# **802.3ck D2.2 Comment Resolution Annex 120G (C2M)**

Matt Brown, Huawei, P802.3ck Editor-In-Chief

Figure 120G-12—Recommended channel differential-mode to differential-mode insertion loss

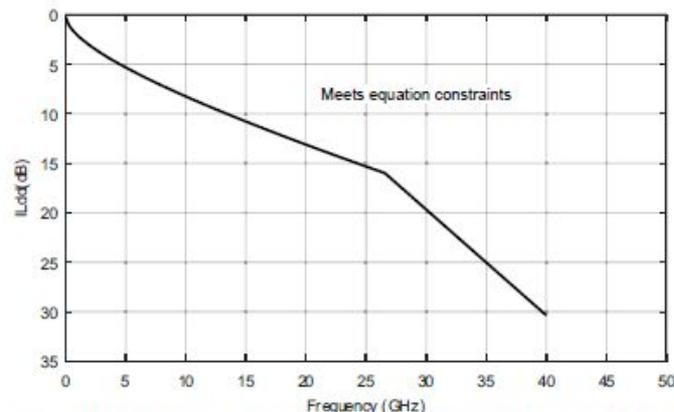
"For correct operation, the actual differential-mode to differential-mode insertion loss could be higher or lower than that given by Equation (120G-3) due to the channel ILD, return loss, and crosstalk"

This sentence is meaningless as written, and not helpful for readers, whatever the intended meaning is.

Looking at 83E, there was no such statement; the insertion loss that was provided in Equation (83E-1) was described as "typical application" with no attempt to make it even a recommendation. 120E changed it to a recommendation but did not add the quoted statement either.

This seems like a statement from the days when channels were specified by insertion loss limits, and that was a poor specification. We have no ground for making Equation 120G-3 anything other than a recommendation; and as such it does not need any disclaimers.

Delete the quoted sentence.

PROPOSED REJECT.

It is not clear what value the reference sentence has, however there may have been some sound logic for including it.  
For task force discussion.

Figure 120G-11—Module stressed input target high-loss frequency-dependent attenuator differential-mode to differential-mode insertion loss

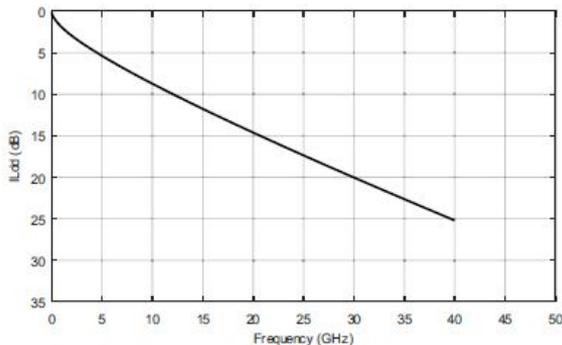
Graph the target up to the signalling rate as done in Figure 163B-1, delete the editor's note on the previous page.

PROPOSED ACCEPT IN PRINCIPLE.  
Resolve using the response to comment #8.

Comment #8 proposes the constraint is from 0.1 GHz to 40 GHz.

The equations provide the complex s-parameters necessary as a target for the frequency-dependent loss and the  $IL_{dd}$  in decibels is provide in Figure 120G-11. It is not necessary to provide yet another equation.
